HISTORIC AND DESIGN REVIEW COMMISSION

June 03, 2020

HDRC CASE NO: 2020-210
ADDRESS: 132 CAMARGO
LEGAL DESCRIPTION: NCB 923 BLK 4 LOT N 75FT OF E 27.8FT OF 6 & N 75FT OF 7
ZONING: RM-4,H
CITY COUNCIL DIST.: 1
DISTRICT: Lavaca Historic District
APPLICANT: Robert Alvarado/South Antonio Builders
OWNER: Kathryn Ruckman/BEANVILLE BUNGALOWS LLC
TYPE OF WORK: Exterior alterations, site modifications
APPLICATION RECEIVED: May 15, 2020
60-DAY REVIEW: Not applicable due to City Council Emergency Orders
CASE MANAGER: Stephanie Phillips

1 132 CAMARGO - NORTH ELEVATION

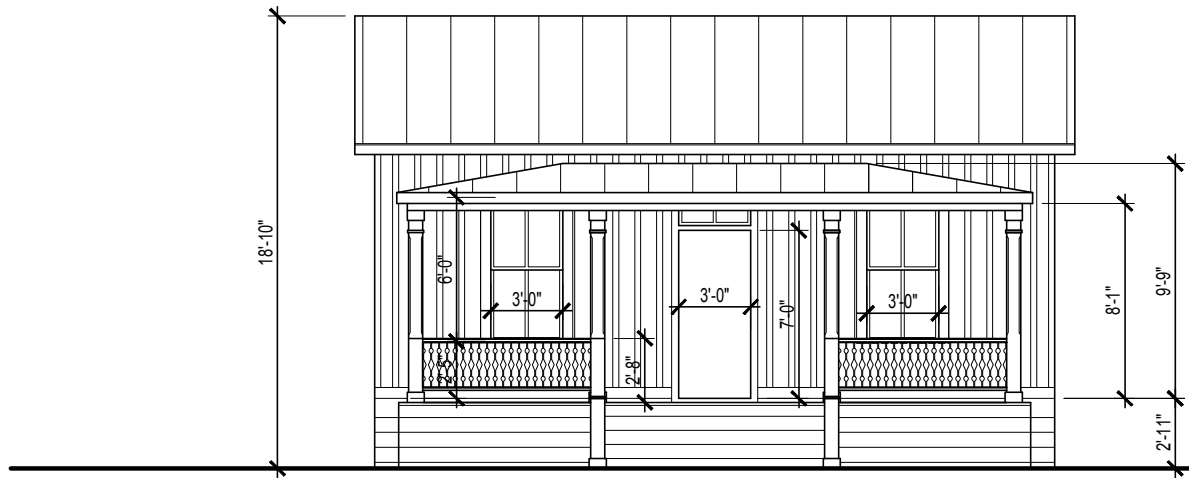
- b. PORCH - The applicant has proposed to rebuild the front and side porch to historic configuration, including columns, rails, balustrade, and brackets. The porch will feature square columns with a simple traditional base and capital and the proposed railing will feature turned balustrades, which are common of the Folk Victorian style. According to the Historic Design Guidelines, porches, balconies, porte-cocheres, and related elements, such as ceilings, floors, and columns, should be replaced in-kind when such features are deteriorated beyond repair or missing. When in-kind replacement is not feasible, the design should be compatible in scale, massing, and detail while materials should match in color, texture, dimensions, and finish. Staff finds the proposal generally consistent with the Guidelines.

- i. That the columns be no wider than 6x6” and feature a traditional capital and base and chamfered corners. The applicant is required to submit a detailed column drawing with dimensions prior to the issuance of a Certificate of Appropriateness.

1 132 CAMARGO - PLAN OPTION 3

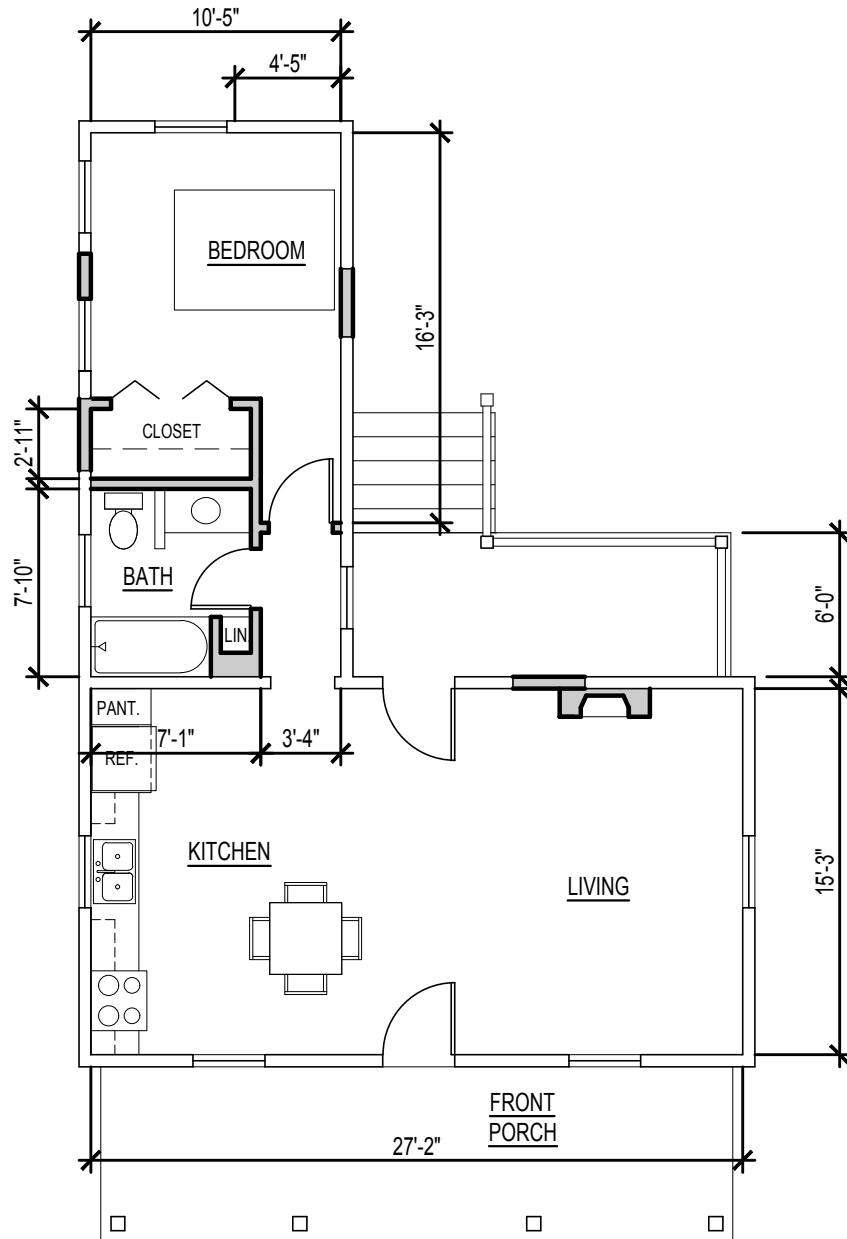
- e. WALKWAY – The applicant has proposed to install a poured concrete walkway and curb from the street leading up to the new proposed staircase. According to the Historic Design Guidelines, the historic alignment, configuration, and width of sidewalks and walkways should be followed. Staff finds the proposal consistent with the Guidelines.

- f. DRIVEWAY – The applicant has proposed to install a new rear driveway. The driveway will measure 10 feet in width and will be constructed decomposed granite with brick lining the perimeter. The apron will be poured concrete. According to the Guidelines, a similar driveway configuration—materials, width, and design—to that historically found on the site should be incorporated. Historic driveways are typically no wider than 10 feet. Pervious paving surfaces may be considered where replacement is necessary to increase stormwater infiltration. Staff generally finds the proposal appropriate, but requires a material specification and dimension for the brick.

- g. SIDE PARKING AREA – As noted on the site plan, the applicant is requesting to install a decomposed granite parking area along the side of San Arturo street. According to the Guidelines, new parking areas should follow the historic development pattern of the district. Staff does not find this proposed parking area appropriate.

- i. That the concrete walkway be no wider than 4 feet.
- ii. That the driveway be no wider than 10 feet and that the approach flares to no wider than 12 feet at its widest point.

- i. That the driveway be no wider than 10 feet and that the approach flare to no wider than 12 feet at its widest point. The applicant is required to submit a material specification and dimension for the brick. Staff finds a brick that closely matches the color of the decomposed granite to be most appropriate.

Item 5, Staff does not recommend approval of the parking pad along the side of San Arturo street as noted in finding g.
